SUBJECT: DOE-NRC TECHNICAL MEETING SUMMARY

NRC DATA REVIEW OF GEOPHYSICAL DATA FOR THE PARADOX BASIN
16 to 18 October, 1984
Woodward-Clyde Consultant office
San Francisco, CA

GEOLOGY-GEOPHYSICAL DATA REVIEW CHECKLIST

SEFEL GEOPHYSICAL
SEISMIC DATA PROCESSING
DENVER COLORADO

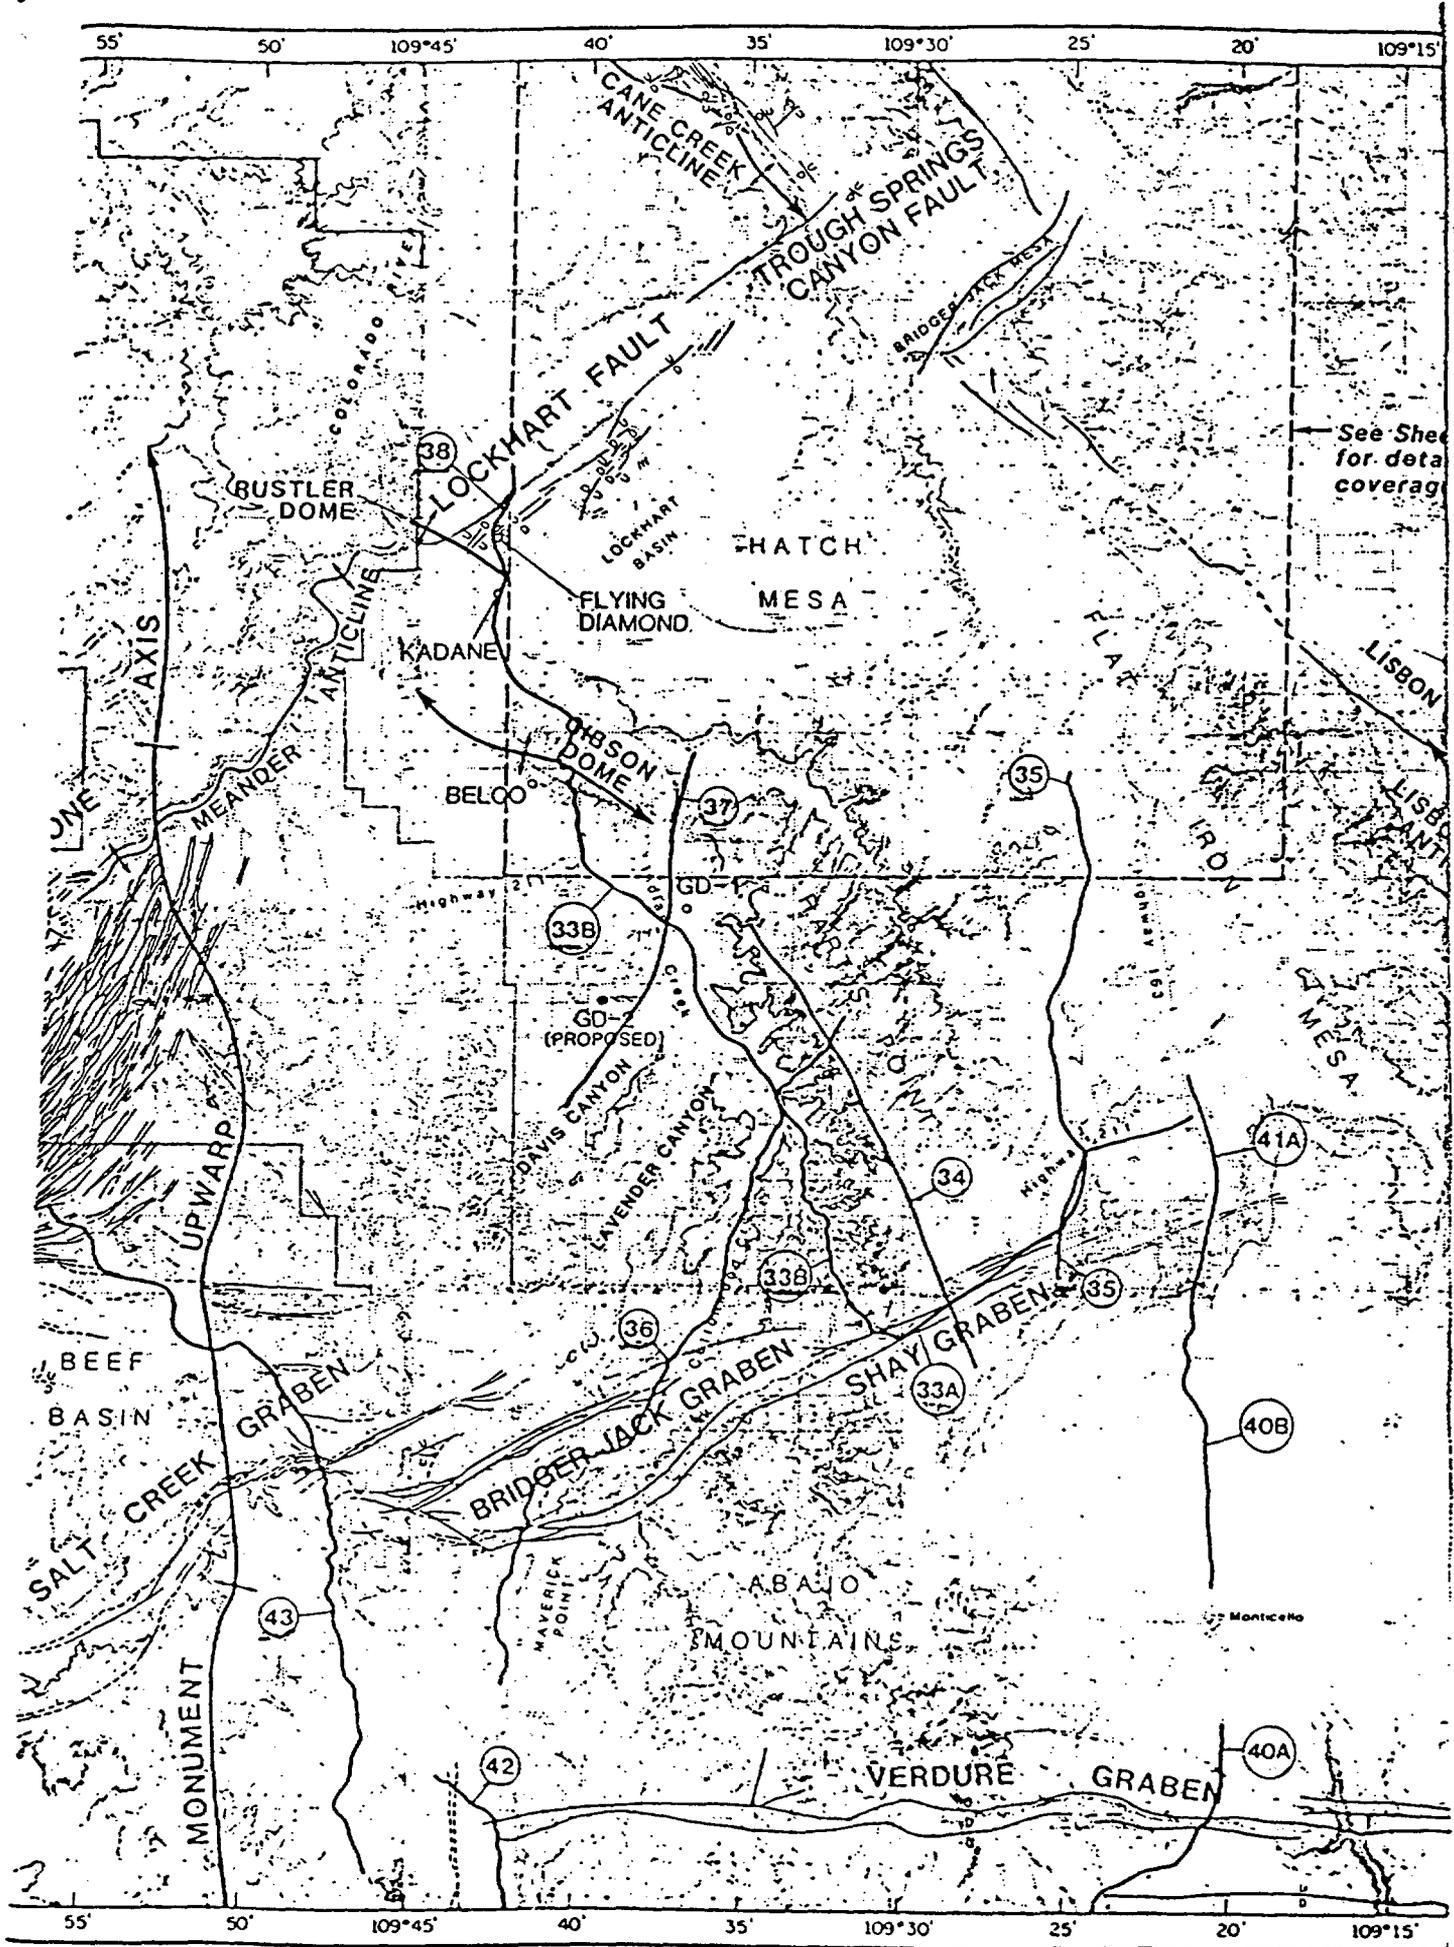
3a. How were the reliabilities* of the instruments specified?
WCC RELIED UPON CONTRACTOR WHOSE QC LABEL IS ON SEISMIC HEADER SHEET (SEE ATTACHED).

PROCESSING PROCEDURE IN SEG-B FORMAT AS SHOWN ON ATTACHED HEADER SHEET EXAMPLE.

NORMAL DATA PROCESSING USED. SEE ATTACHED HEADER SHEET
EXAMPLE FROM LINE 37 DAVIS CANYON AREA.
